Docket Number:	15-AFC-01
Project Title:	Puente Power Project
TN #:	213641
Document Title:	Comments on Preliminary Staff Assessment from The Nature Conservancy
Description:	N/A
Filer:	System
Organization:	The Nature Conservancy
Submitter Role:	Public
Submission Date:	9/14/2016 12:11:31 PM
Docketed Date:	9/14/2016

**Puente Power Plant (15-AFC-01) Comments on Preliminary Staff Assessment from
The Nature Conservancy**

Re: Puente Power Plant (15-AFC-01) Comments on Preliminary Staff Assessment from The Nature Conservancy

Map 1: Current Coastal Flood Risk - City of Oxnard Electric Power Generation Facilities

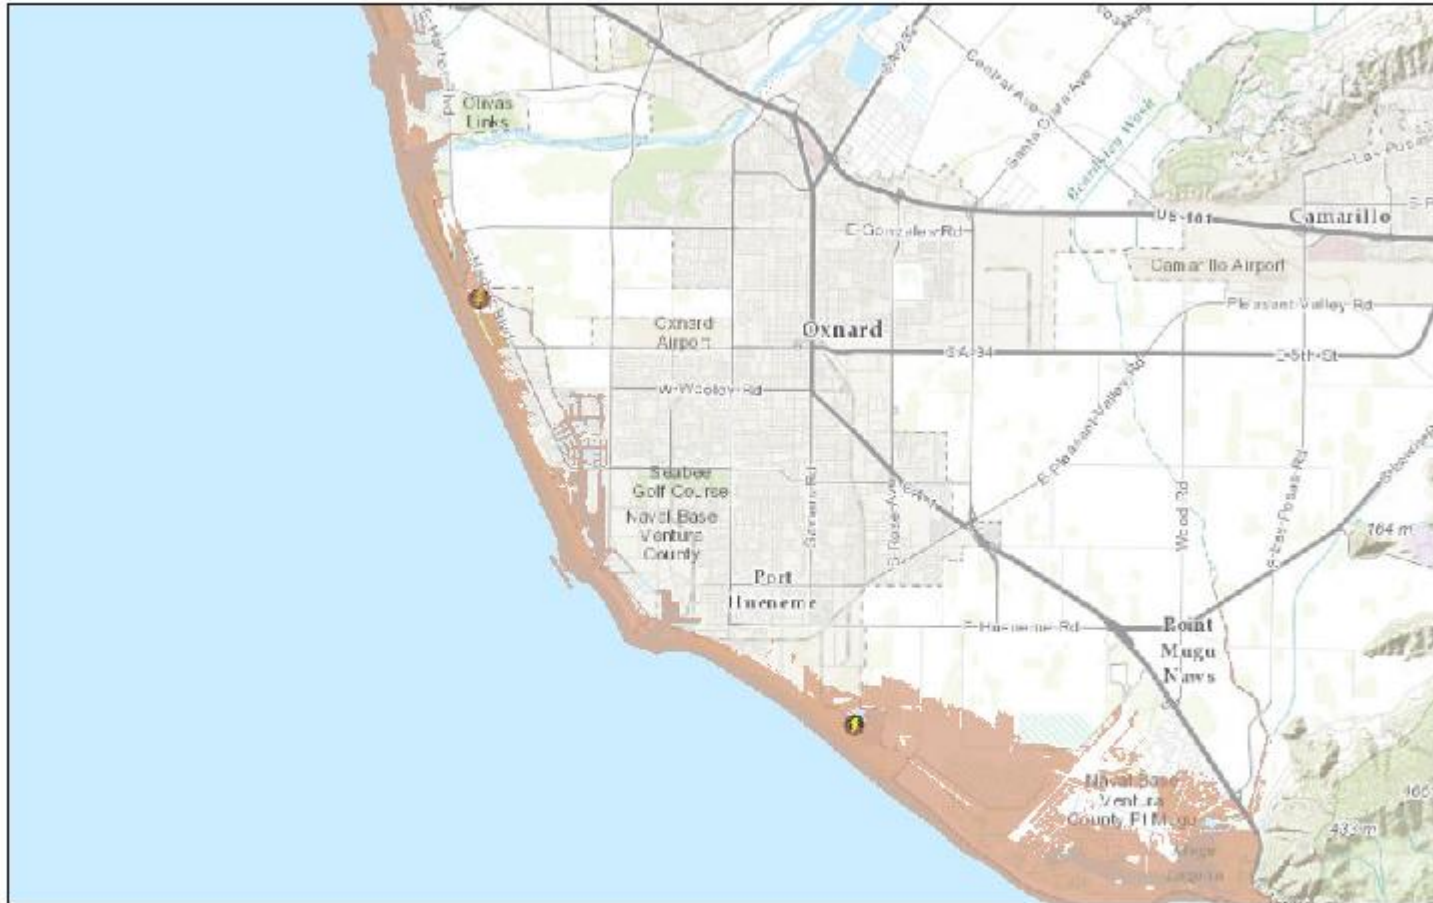
The PSA evaluated SLR impacts to the proposed Puente Power Project site with the preliminarily released results of the Coastal Storm Modeling System (CoSMoS 3.0). It is noted in the PSA that these are initial results from a preliminary release of CoSMoS 3.0; however, it is not noted that the preliminary results do not show erosion or cliff retreat included in those flood projections nor do they model the combined risks of these hazards. Final results from the Coastal Resilience Ventura climate hazards model are complete, comprehensive, and model combined risks of multiple hazards. These results clearly indicate existing risks in coastal Ventura County - and specifically at the proposed site of the proposed Puente Power Project (Map 1) - that increase over time. These results also show significant risks of coastal erosion and flood hazards under various future climate scenarios at the site (Map 2).
